ADDENDUM NO. 0

Date: May 11, 2022

Issued by: Sacramento City Unified School District

Project: **SCUSD Project No. 454-2
Shade Structures Group 1B**

ENLARGED PLAN **A1.1.1**
 SHADE STRUCTURE AT JOHN D. SLOAT
 ELEMENTARY SCHOOL
 SACRAMENTO CITY UNIFIED SCHOOL DISTRICT
 SACRAMENTO, CA
 DSA APP.02-119974

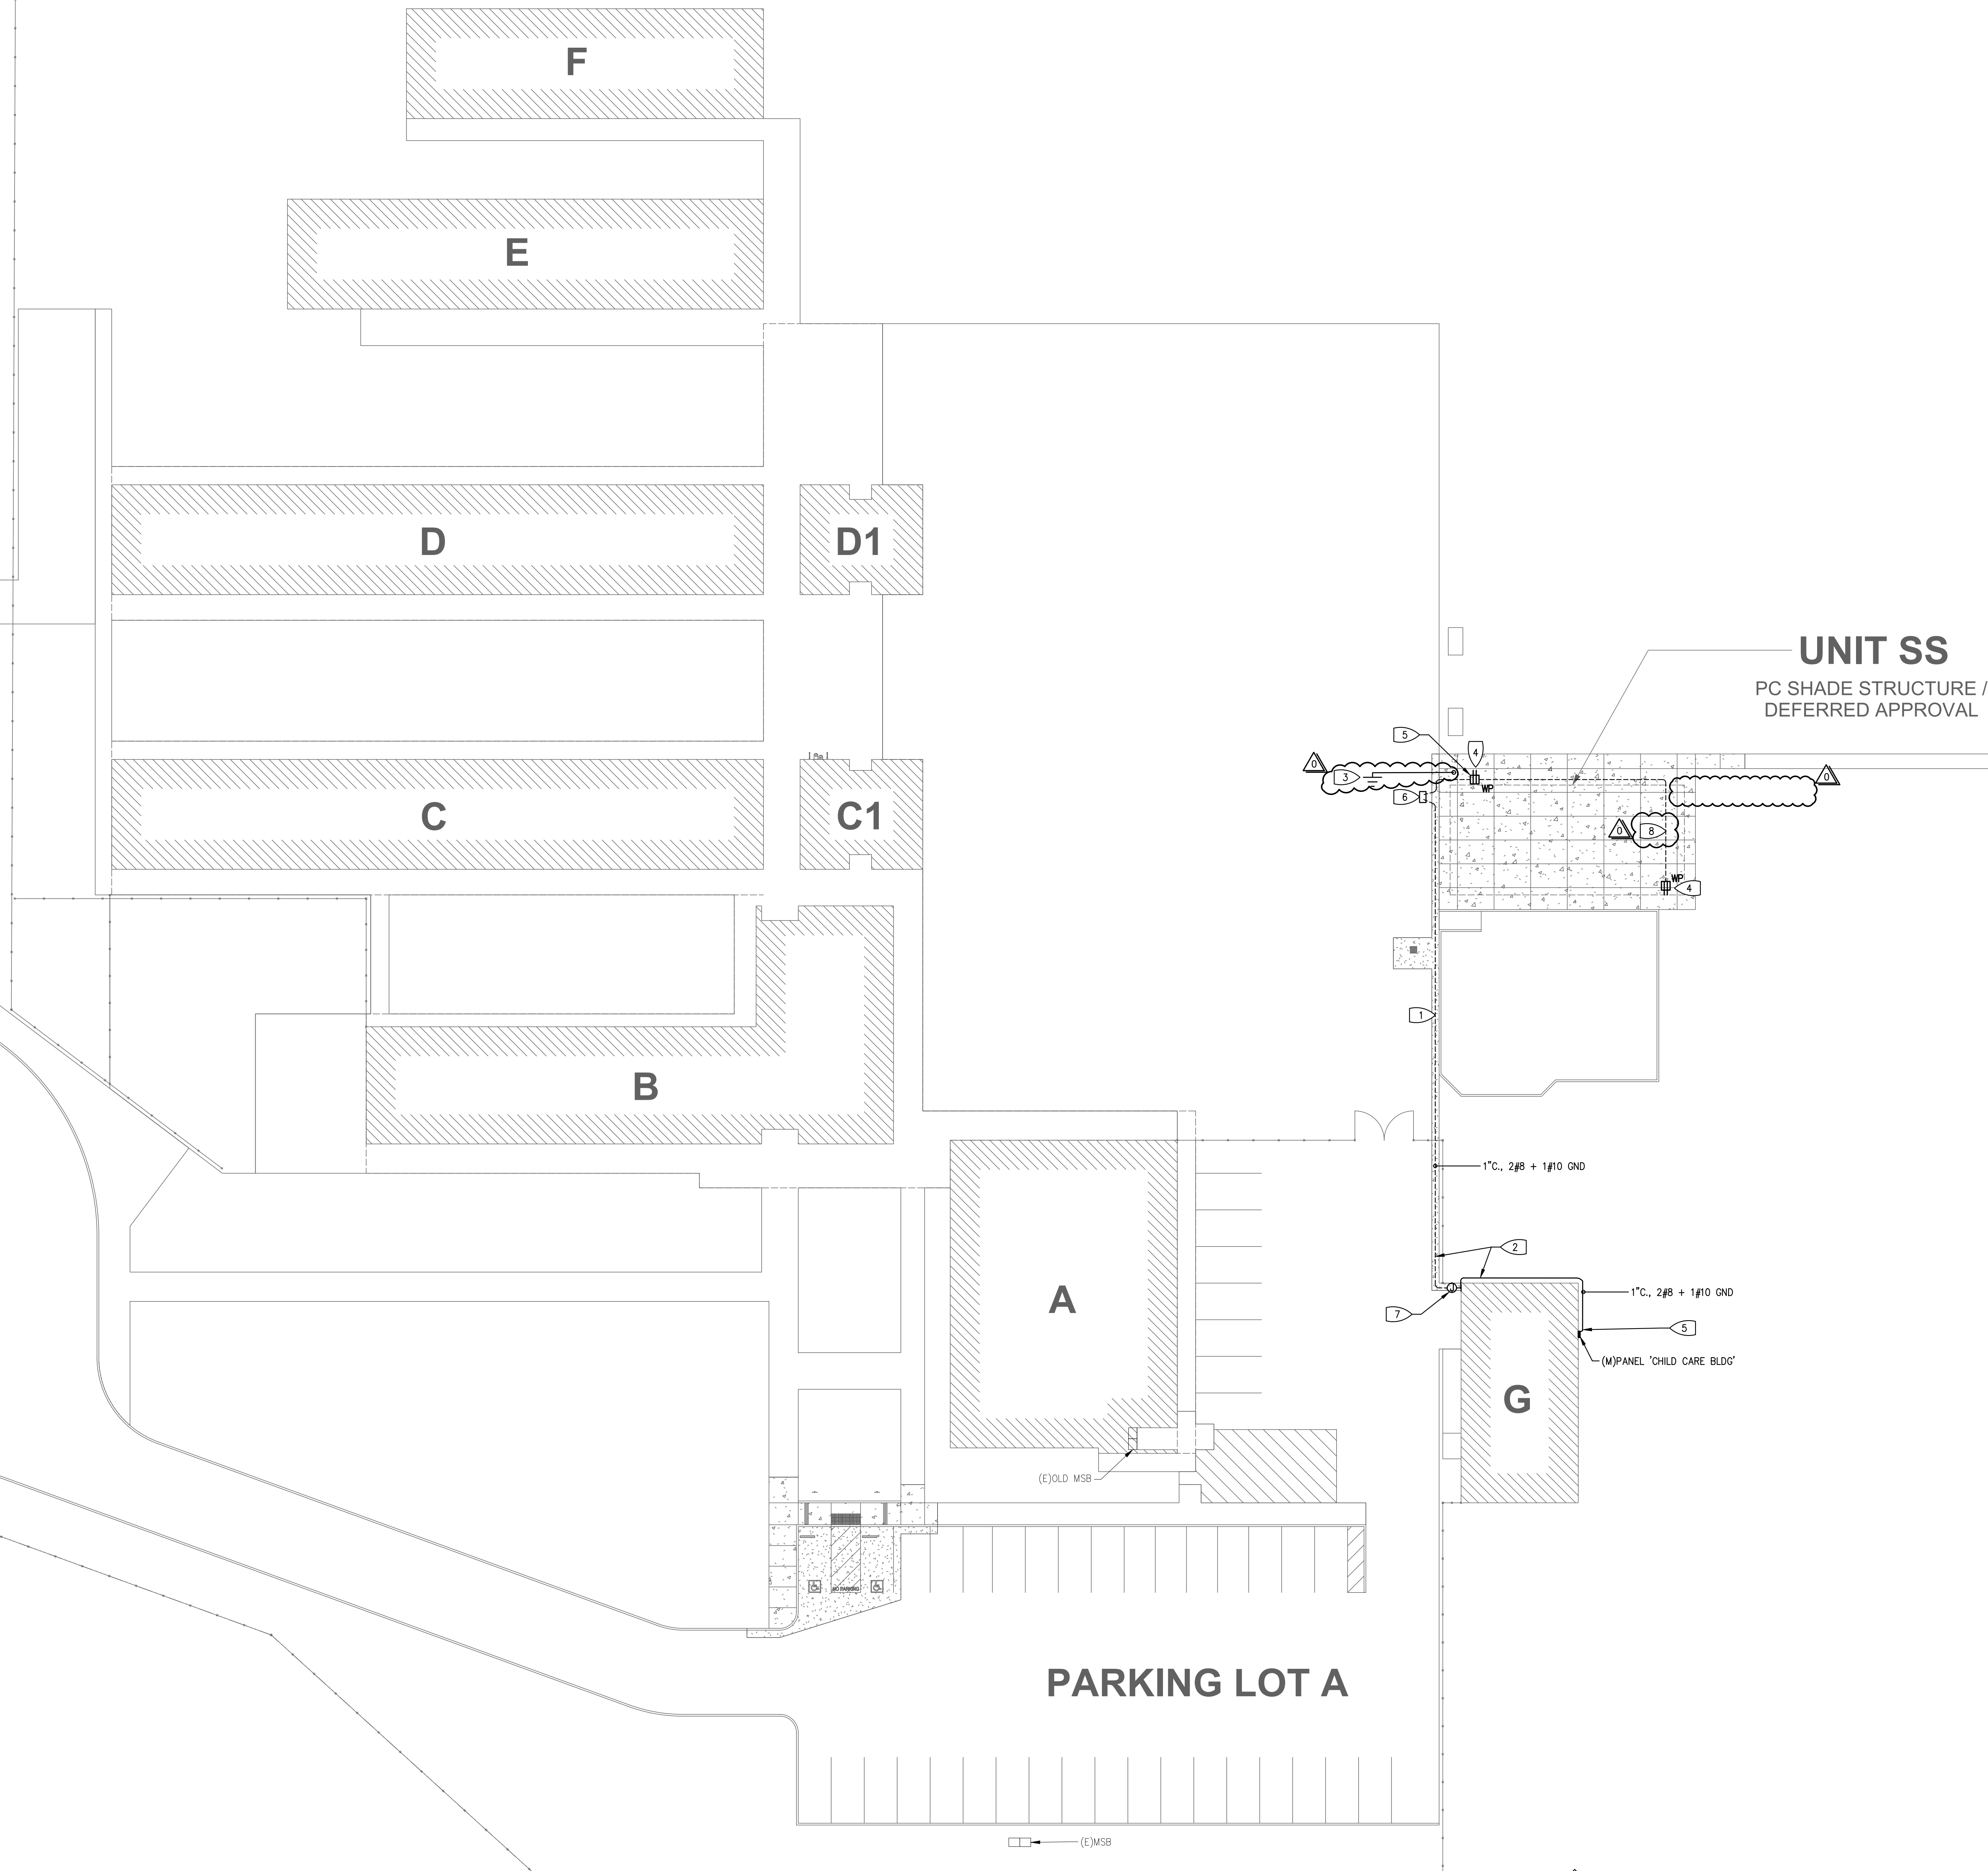
1. ADD Landscape / Irrigation Note per sheet AD0.02 included with this addendum.
- C. Sheet A1.1.1, Partial Site Plans and Details
 1. Detail 2, Enlarged Site Plan – Shade Structure: REVISE site plan to now show a section callout at the shade structure column per sheet AD0.03 included with this addendum.

2. Sheet Note 4: ADD note. Text to read “For footing / concrete pad / column interaction, see PC shade structure / deferred approval”
- D. Sheet E1.1, Site Plan - Electrical

1 SITE PLAN - ELECTRICAL
 SCALE: 1"=20'

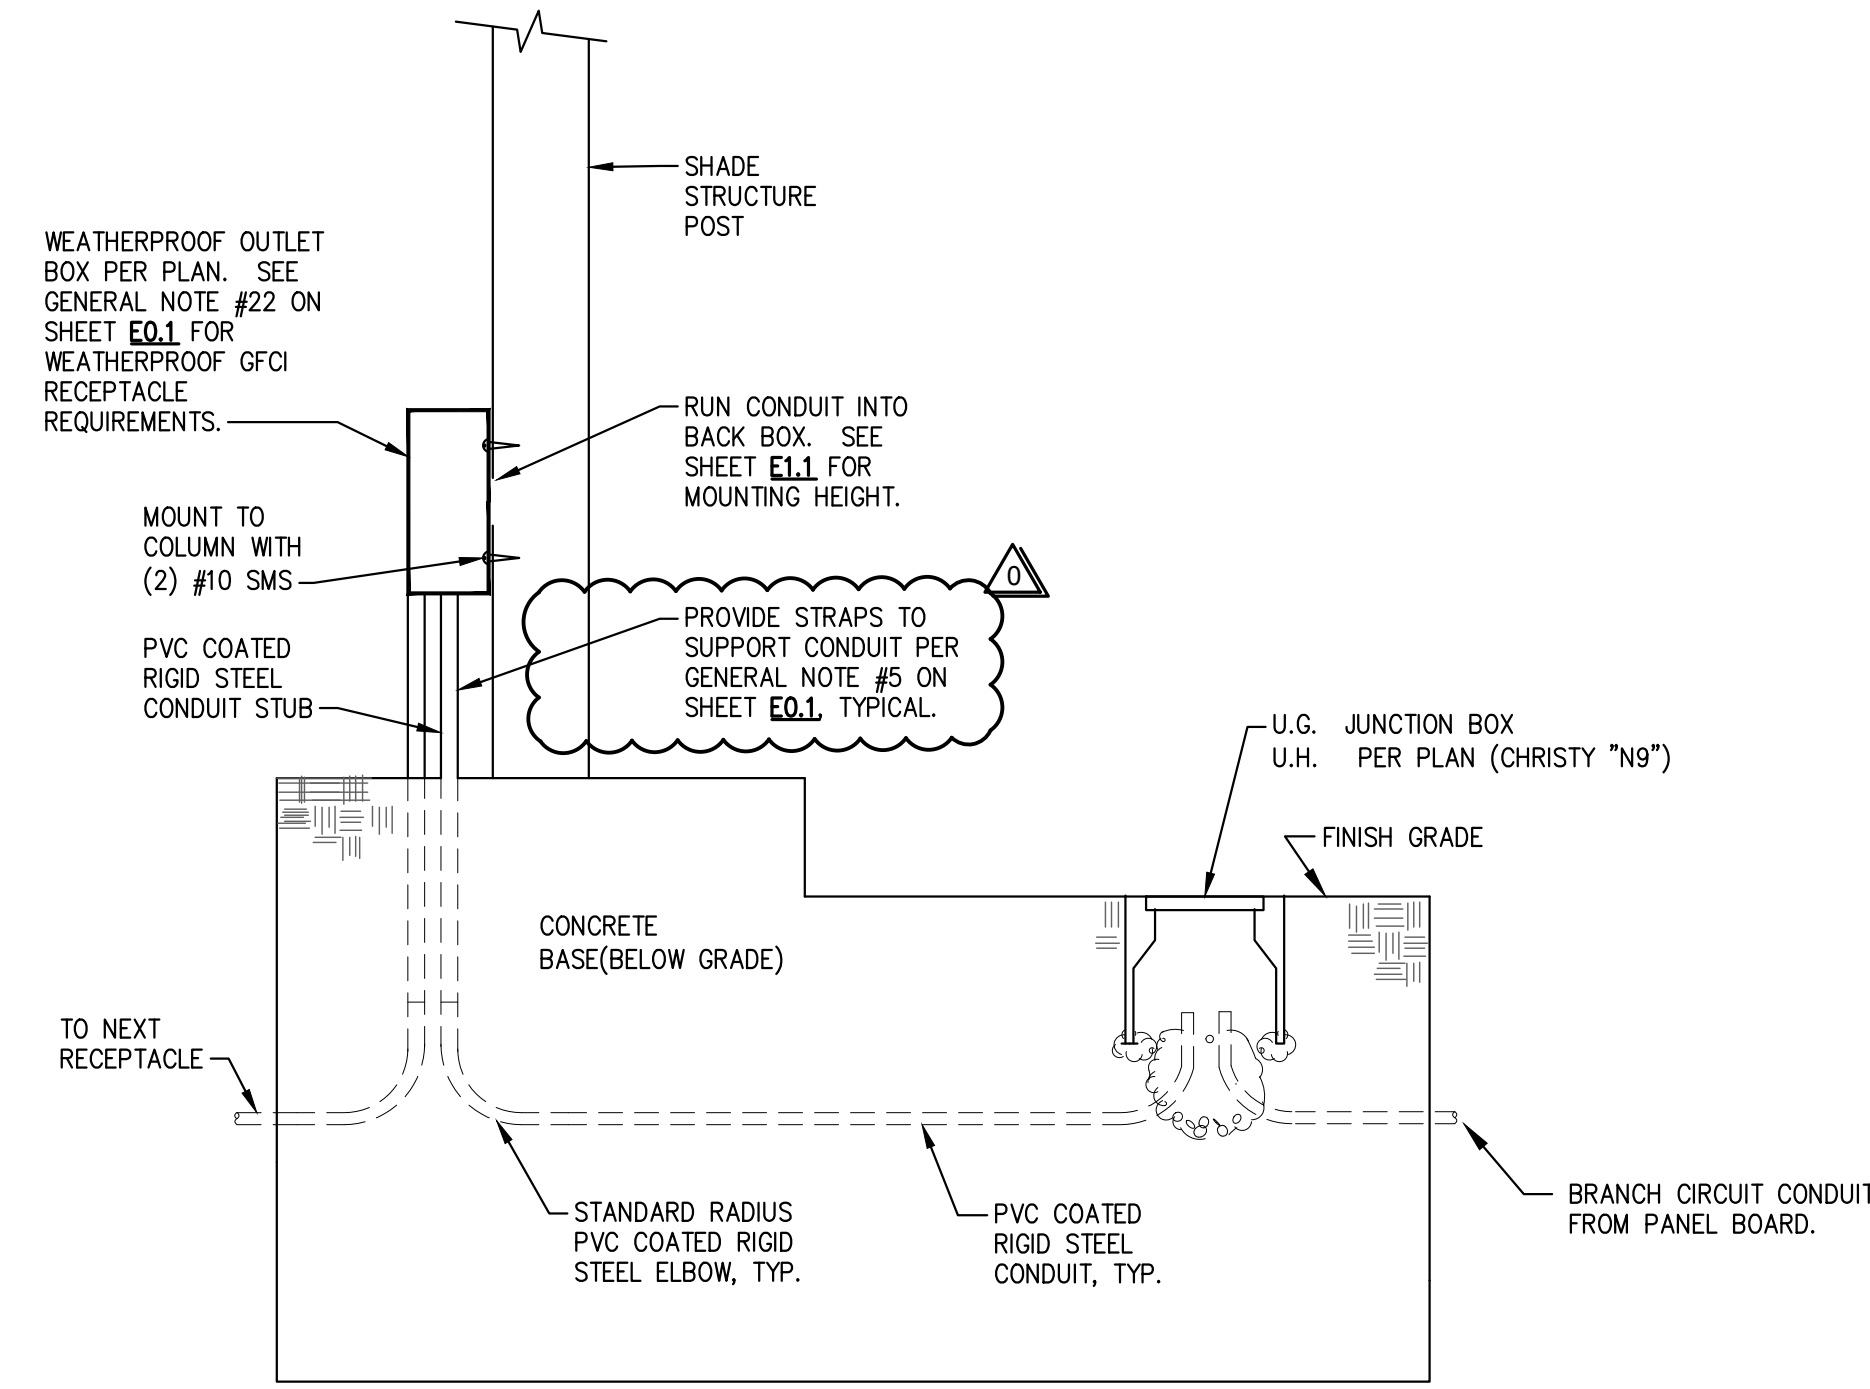
1. REVISE conduit and ground rod callouts per sheet AD0.04 included with this addendum.
 2. REVISE Keyed Notes 1 and 3 per sheet AD0.04 included with this addendum.

3. ADD Keyed Note 8 per sheet AD0.04 included with this addendum.
- E. Sheet E3.1, Details
 1. Detail 2, Typical H/20 Traffic Rated Pull Box: REVISE per sheet AD0.05 included with this addendum.

5 TYPICAL STEEL COLUMN & REBAR GROUNDING DETAIL
SCALE: NONE

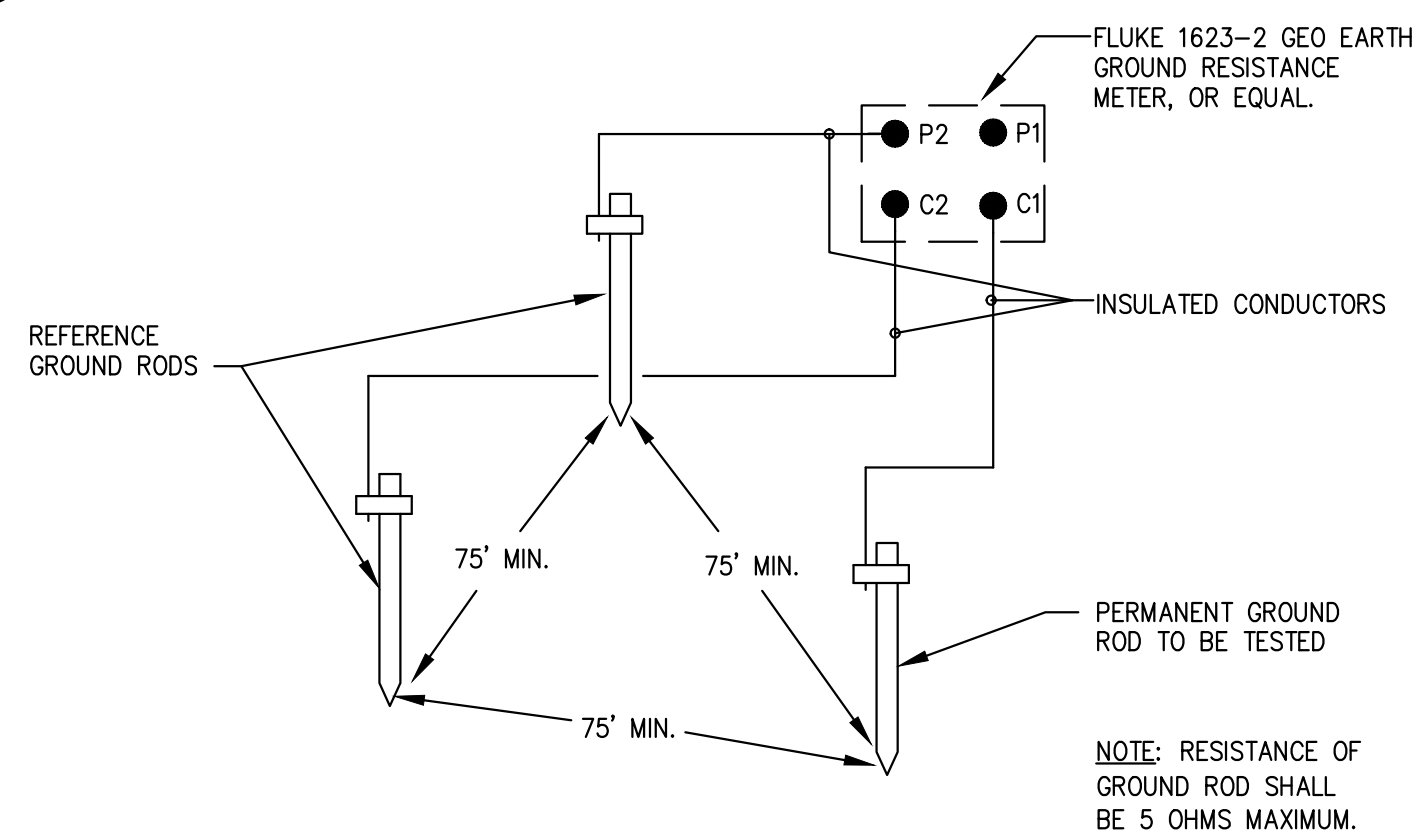
2. Detail 4, Conduit Stub in Post Detail: REVISE per sheet AD0.05 included with this addendum.
 3. Detail 5, Typical Steel Column & Rebar Grounding Detail: REVISE per sheet AD0.05 included with this addendum.

4 WATER TRENCH NO SCALE

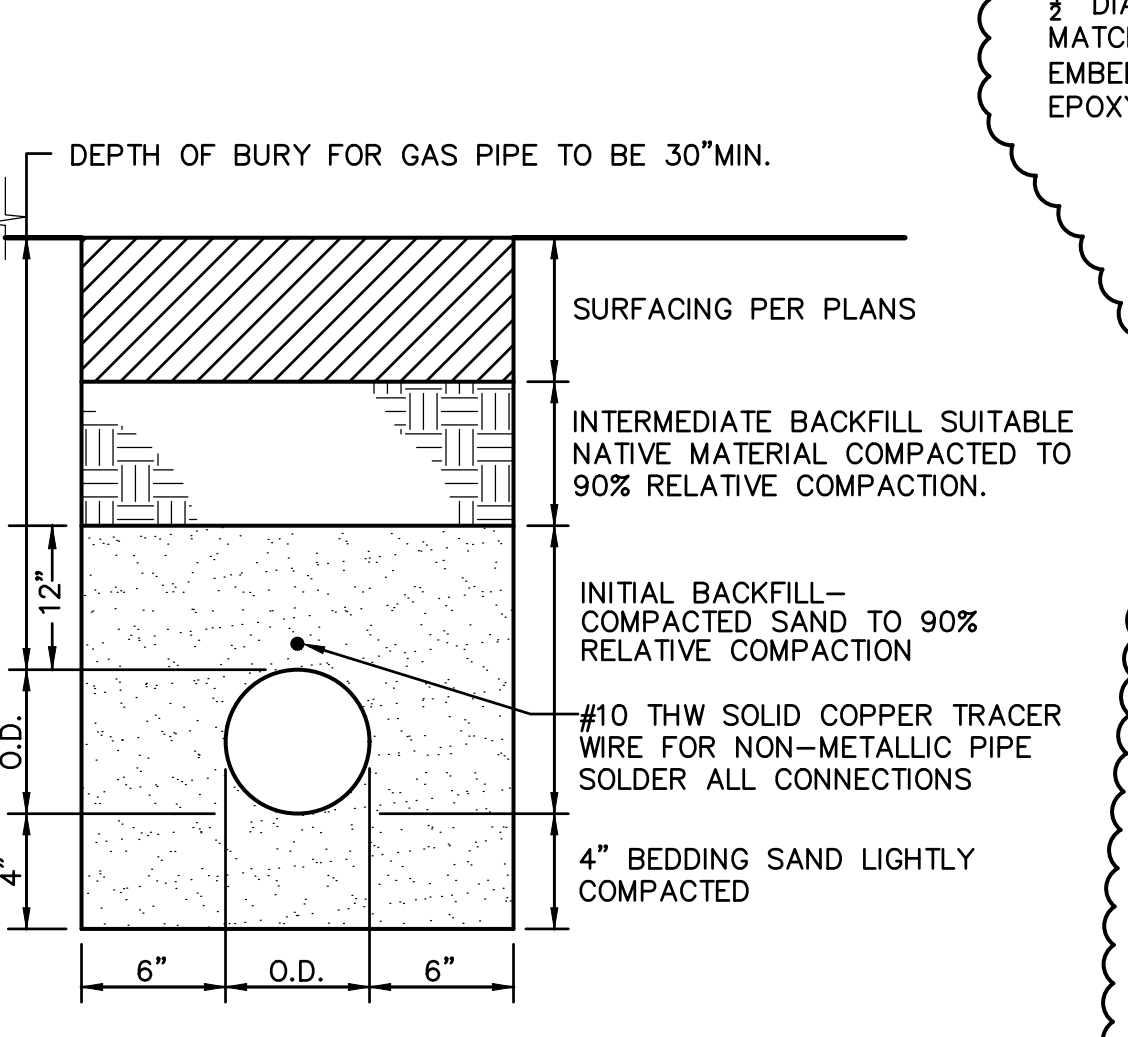
7. Detail 4, Water Trench: ADD per sheet AD0.02 included with this addendum.
- D. Sheet A1.1.0, Site Plan and Code Information
1. Detail 1, Site Plan: REVISE planter at Unit SS to curb per AD0.03

2 CONCRETE CURB NO SCALE

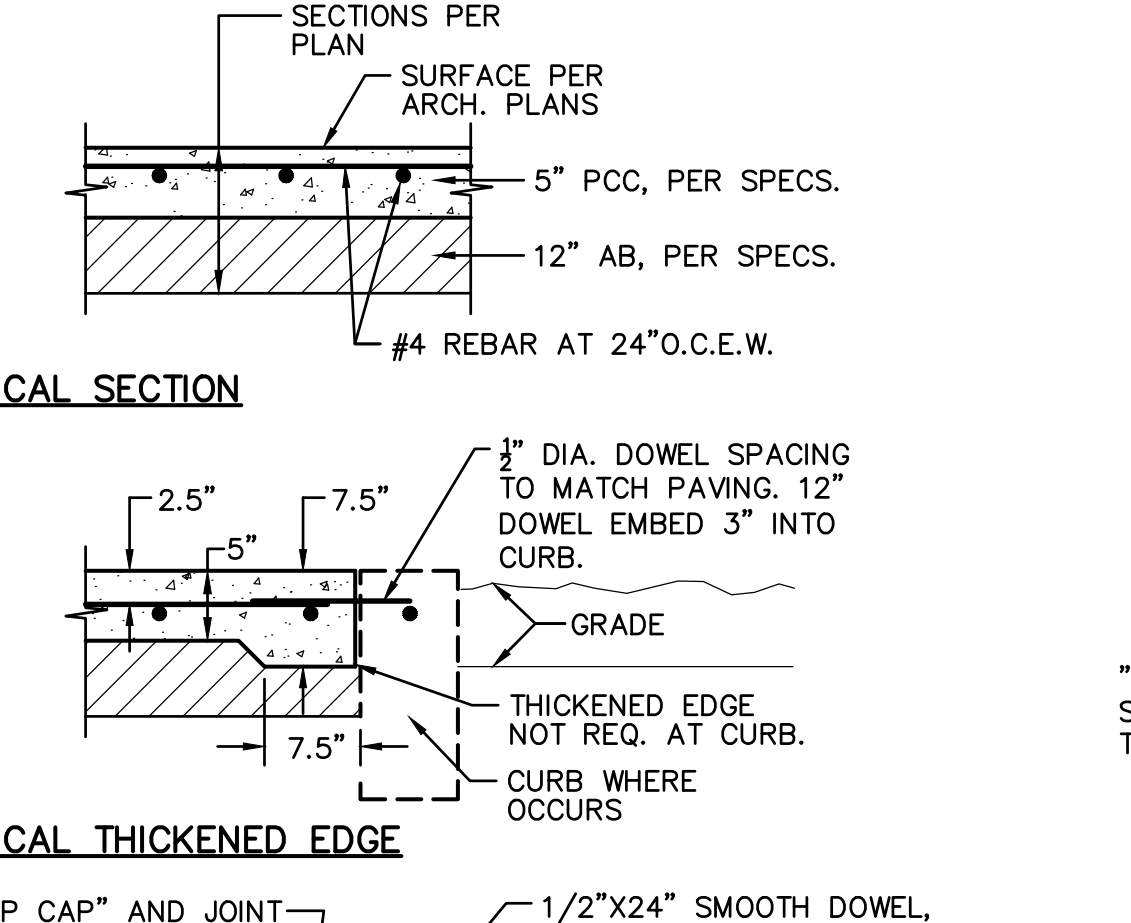
- 4. ADD Grading Note 19 per sheet AD0.02 included with this addendum.
 - 5. ADD Demolition Note 5 per sheet AD0.02 included with this addendum.
 - 6. Detail 2, Concrete Curb: REVISE per sheet AD0.02 included with this addendum.
